PIC18F1XK22/LF1XK22 Family

Silicon Errata and Data Sheet Clarification

The PIC18F1XK22/LF1XK22 family devices that you have received conform functionally to the current Device Data Sheet (DS41365C), except for the anomalies described in this document.

FIGURE 1: INSTRUCTION CYCLE DELAY CALCULATION EXAMPLE

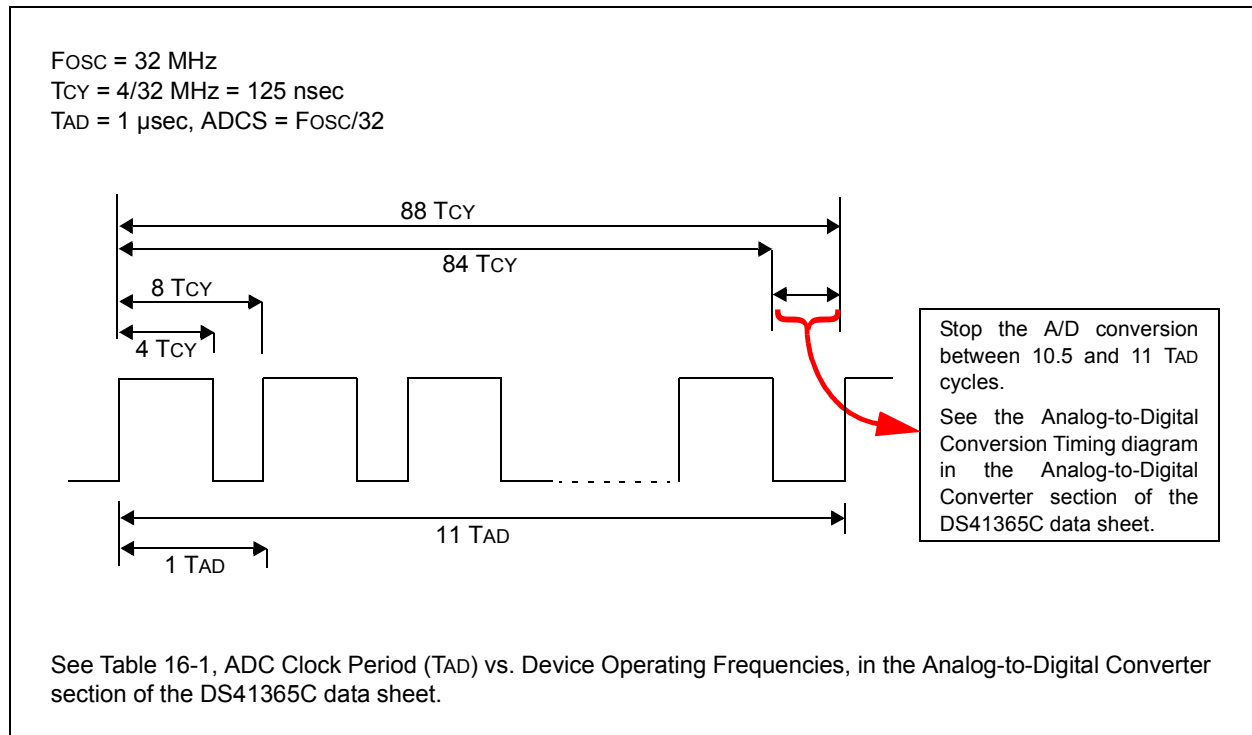
- 1.2 Under certain device operating conditions, the ADC conversion may not complete properly. When this occurs, the ADC Interrupt Flag (ADIF) does not get set, the ADGO/DONE bit does not get cleared, and the conversion result does not get loaded into the ADRESH and ADRESL result registers.

Method 2: Provide a fixed delay in software to stop the A-to-D conversion manually, after all 10 bits are converted, but before the conversion would complete automatically. The conversion is stopped by clearing the GO/DONE bit in software. The GO/DONE bit must be cleared during the last ½ TAD cycle, before the conversion would have completed automatically. Refer to Figure 1 for details.

In Figure 1, 88 instruction cycles (Tcy) will be required to complete the full conversion. Each TAD cycle consists of 8 Tcy periods. A fixed delay is provided to stop the A/D conversion after 86 instruction cycles and terminate the conversion at the correct time as shown in the figure above.

Note: The exact delay time will depend on the choice of Fosc and the TAD divisor (ADCS) selection. The Tcy counts shown in the timing diagram above apply to this example only. Refer to Table 3 for the required delay counts for other configurations.
